# RPZ Consultation 2022 Amendment Report for Formal TRO Consultation Entry Hill area

(Widcombe & Lyncombe, and Combe Down Wards, Bath)

Bath and North East Somerset Council

10<sup>th</sup> August 2022

**Figure 2: Existing and proposed RPZ areas surrounding the properties bound by Wellsway, Devonshire Villas and Greenway Lane**

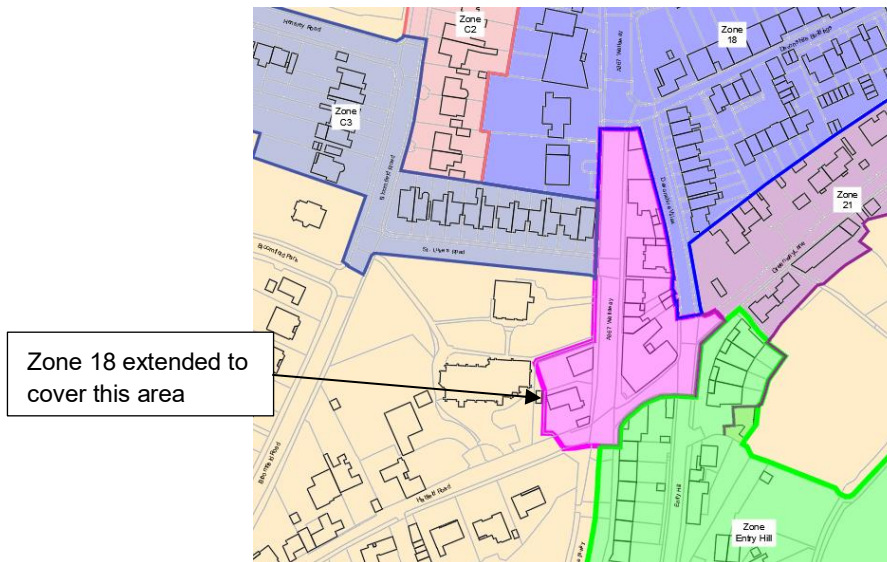
- 1) Residents in the triangle of properties bound by Wellsway, Devonshire Villas and Greenway Lane (Highlighted pink in Figure 2) have asked to be added to the existing zone 18. A petition has been submitted to call for this.

**Figure 3: Removal of double yellow lines outside property 133 Wellsway to provide additional parking**

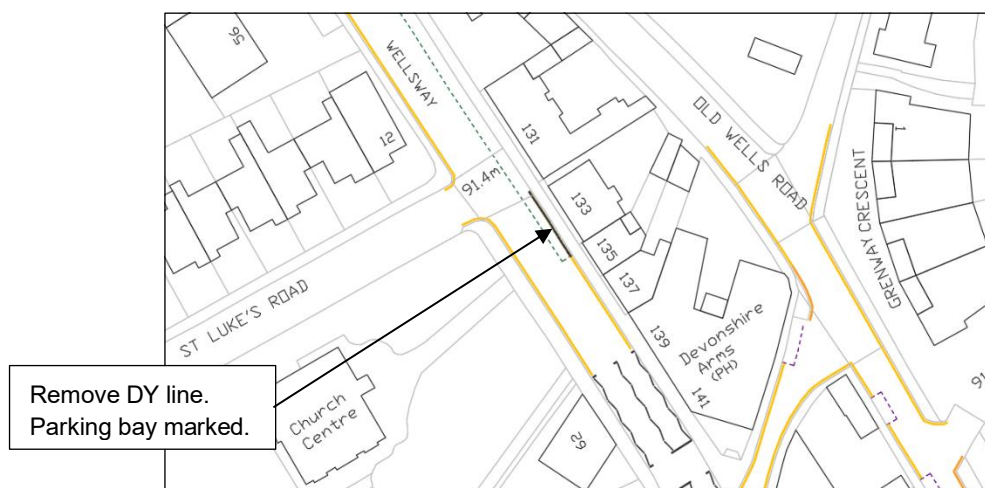
- 2) The extents of the proposed bay outside properties 129 – 141 Wellsway within Zone 18 extension area. The proposed bay is shown to supersede a section of the double yellow lines which currently exists outside properties 133 / 139 Wellsway. There is sufficient carriageway width and sufficient forward visibility from both the junction with St Luke’s Road and to the signal-controlled crossing adjacent to Devonshire Arms to allow the bay to be extended and therefore give additional parking on this stretch with no adverse effect on traffic using Wellsway. A local ward councillor suggests “a compromise of putting in another two spaces, but no more” owing to a possible future cycle scheme in the area and “would support two more spaces being for residents parking only outside most of 133 Wellsway”.

**Figure 4: Greenway Crescent as per consultation layout and amended to be incorporated into proposed new Entry Hill zone**

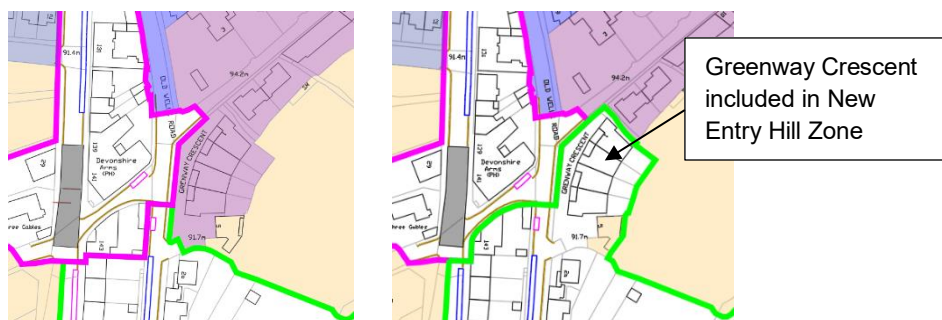
- 3) The ward councillors suggested incorporating Greenway Crescent properties into the Entry Hill zone from the existing Bear Flat zone. Vehicular access into Greenway Crescent is off Entry Hill and, as such, the closest parking for visitors. Any displacement of vehicles would also be onto Entry Hill.

**Figure 5: Entry Hill zone as per consultation layout and amended**

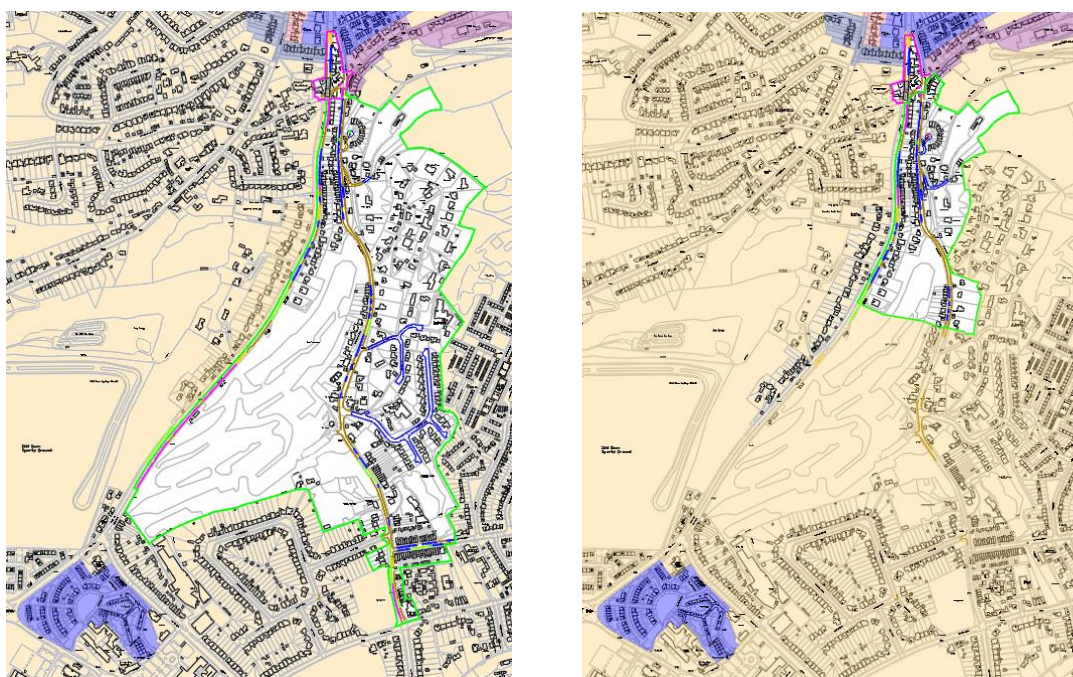
- 4) The ward councillors suggested that local support does exist for a scheme which covers a smaller area than that contained in the public consultation. A smaller area encompassing the northern end of Entry Hill and adjacent streets only is deemed to be preferable and likely to garner overall support from residents within this smaller zone. Therefore the zone extents are to be amended so as to end:
  - a) on Entry Hill at its junction with Longthorne Place, and
  - b) on Wellsway up to and to include property 243.

The west side of Wellsway, the remainder of Entry Hill and the streets off Entry Hill south of Longthorne Place, should be excluded from the revised scheme. Existing waiting restrictions outside of the revised area will remain.

**Figure 7: Bay outside no. 12 removed from scheme and bay outside Brishella converted to dual-use**

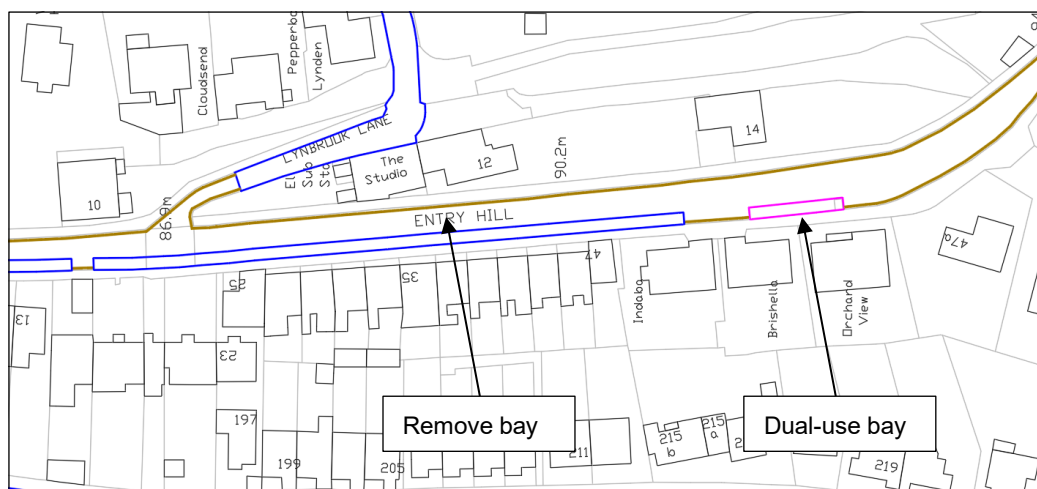
- 8) There will be a signed 'Resident Permit Holders Only' bay outside 145-155 Wellsway rather than a dual-use bay, as first proposed.
- 9) A proposed bay outside 12 Entry Hill is to be removed from the proposals. Residents and ward councillors state that this is likely to cause unnecessary congestion during peak hours.

- 10) A ward councillor has suggested that there should be dual-use parking provision near 47 Entry Hill. "There is room for three spaces to be dual-use outside properties Brishella and Orchard View".

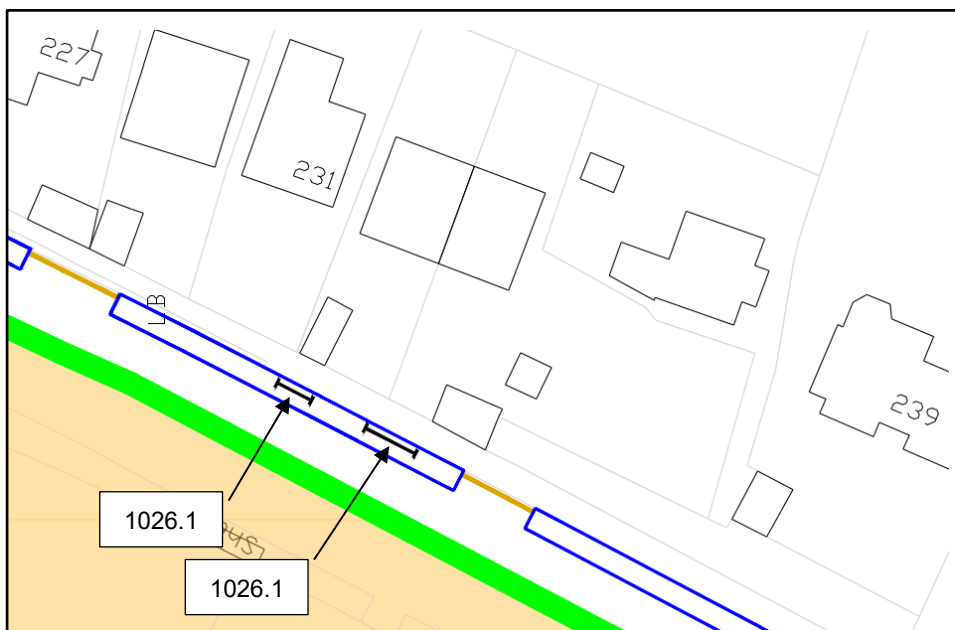
- 11) Request for a parking bay to extend across access and garage at 235 Wellsway. Cllr Duguid commented that “Number 235 Wellsway has a proposed double yellow line outside it. This needs to be replaced with a parking bay. Their “garage” is less than 2.5 metres and is not used as a garage. They want to park where they park now - outside their front gate”.

BaNES comments on this: “Not supportive of placing formal bays across access points. We note the comment about the width, and unless the internal dimensions (not the entrance point) is are below 2.5m we would still consider it an off street parking place. However, we also have to consider what a future owner might wish to use this for. They may have a vehicle (small car. Motorbike etc) that they can accommodate in this garage. BaNES appreciate that the current homeowner/resident uses it for storage, we don't feel it's appropriate to use anything other than a double yellow line [in this location].

Subsequent discussions have resulted in the compromise that the bay will be extended across the garages at properties 233 and 235 and a 'keep clear 'marking to diameter 1026.1 marked across the extents of the dropped-kerb access to the garages. Double yellow lines will be placed across the driveway at 237 as previously proposed.
